**Long Branch Sector Plan, Worksession 2**

**Description**

Following the March 7<sup>th</sup> work session a number of issues were left unresolved. Consequently, they have been added to the March 21<sup>st</sup> agenda as follows:

**Exhibit 1: MTA's Proposed Access to Long Branch Recreation Center and Pool (From Eastbound Direction)**

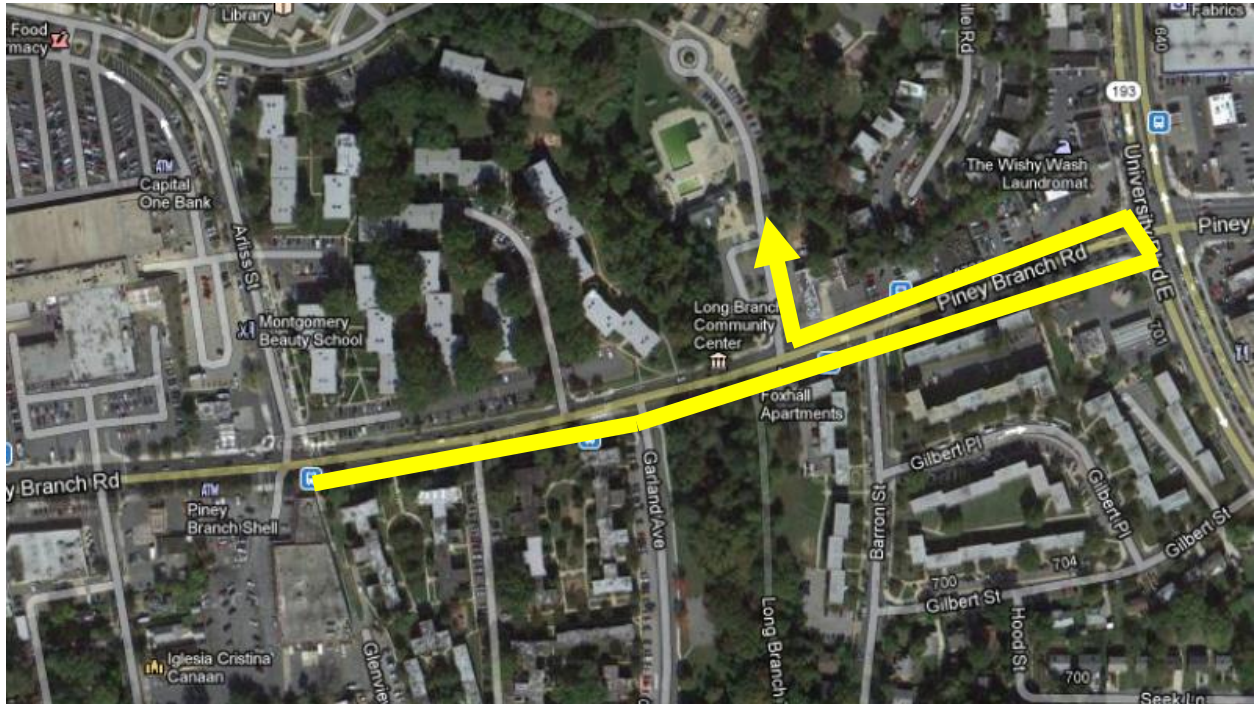
Because the Purple Line is proposed to operate in the median of Piney Branch Road, left turns from Piney Branch Road would be prohibited into Garland Avenue and Barron Street, as well as into and out of all driveways along Piney Branch Road between University Blvd. and Arliss Street. Vehicles intending to make these left turns would be required to travel beyond the intersection, make a U-turn at the next available intersection, and make a right turn onto the desired street or driveway. This is particularly problematic for the Long Branch Pool and Recreation Center.

MTA states that facility patrons will still be able to access the facilities via U-turns at Arliss Street and University. Vehicles traveling in the eastbound direction on Piney Branch Road would have to pass the recreation center, make a U-turn at University Blvd., and then turn right into the recreation center (see Exhibit 1).

**Exhibit 2: MTA's Proposed Egress from Long Branch Recreation Center and Pool (To Eastbound Direction)**

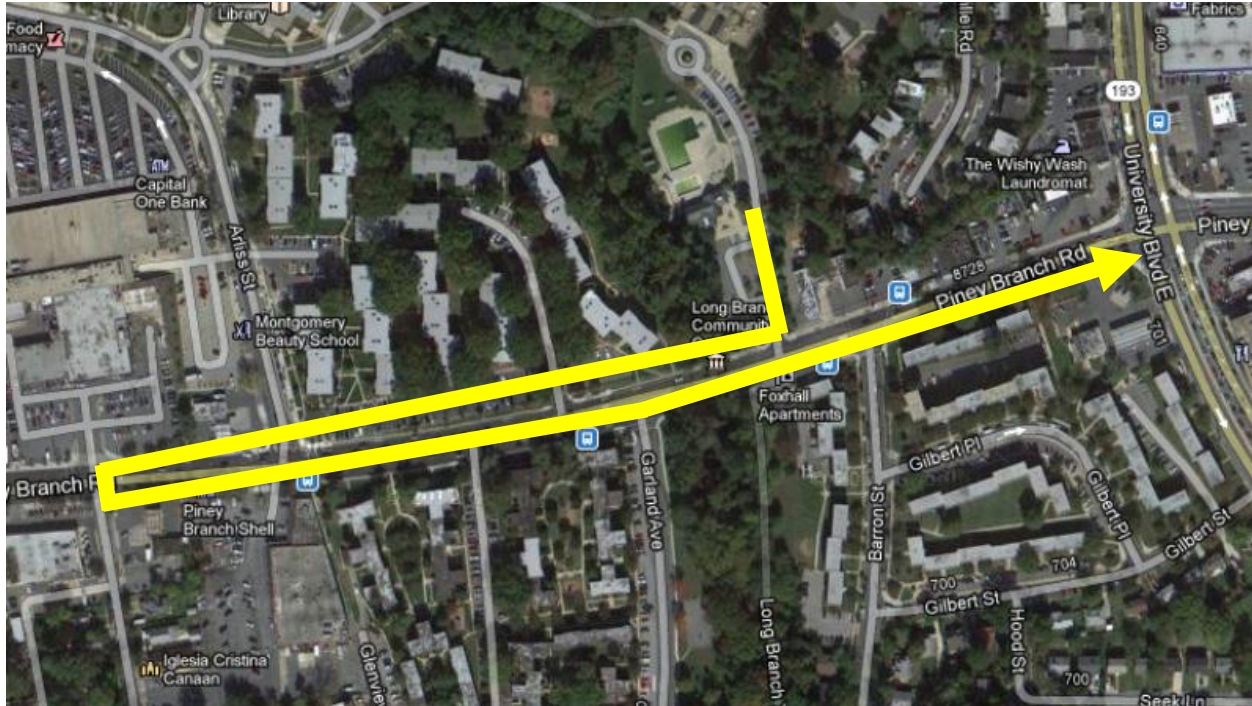
Exiting vehicles headed in the eastbound direction would have to make a right onto Piney Branch Road, make a U-turn at Greenwood Avenue, and then head in the eastbound direction on Piney Branch Road (see Exhibit 2). Of the two access restrictions, the proposed replacement of the entering left turn with a U-turn at University Blvd. is the most concerning.

M-NCPPC staff (Planning Department and Department of Parks) share the concern that these intersections will be complicated enough post-Purple Line and post-Sector Plan implementation and we should not make the intersections even more complicated by encouraging U-turn movements. In addition, the U-turn concept at the intersection of Piney Branch Road and University Blvd. is incompatible with the proposed congestion relief strategy proposed in the Long Branch Sector Plan. This strategy is intended to relocate left turns from eastbound Piney Branch Road to northbound University Blvd. to Gilbert Street Extended proposed at the southwest corner of the intersection.

*A plan view showing a variation of Option 1 that routes visitors to the Long Branch Pool and Recreation Center along Garland Avenue, the proposed Domer Avenue multimodal bridge, and Barron Street.*

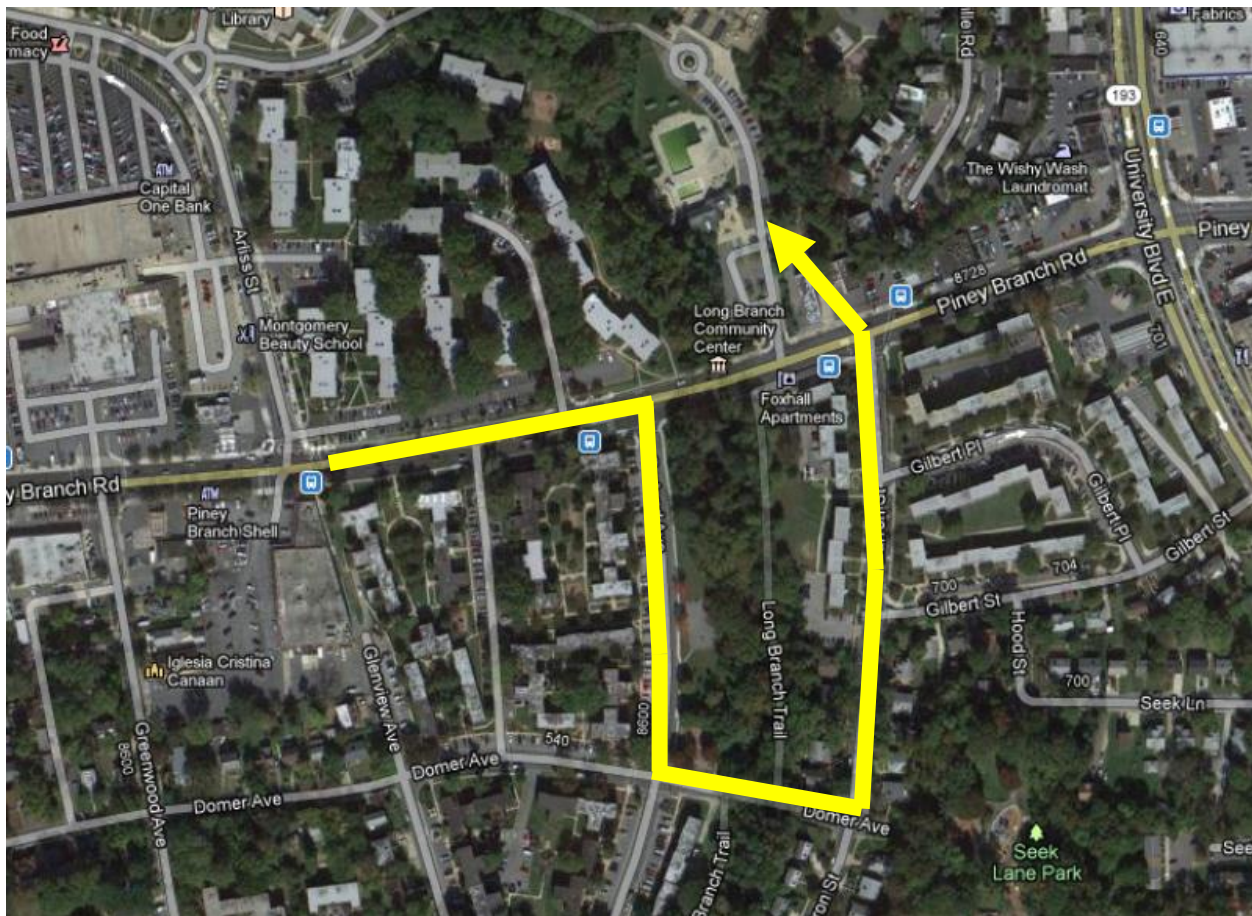
In the February 28<sup>th</sup> briefing, Planning Department staff presented a fourth option – Option 1A – that would realign the driveway with Barron Street, but instead of adding a new left turn lane for eastbound traffic would instead route visitors through south on Garland Avenue, across the proposed Domer Avenue multimodal bridge<sup>3</sup>, and north on Barron Street (see Exhibit 3). M-NCPPC staff believes this option provides the best value to the County because the two components of the access solution have independent utility:
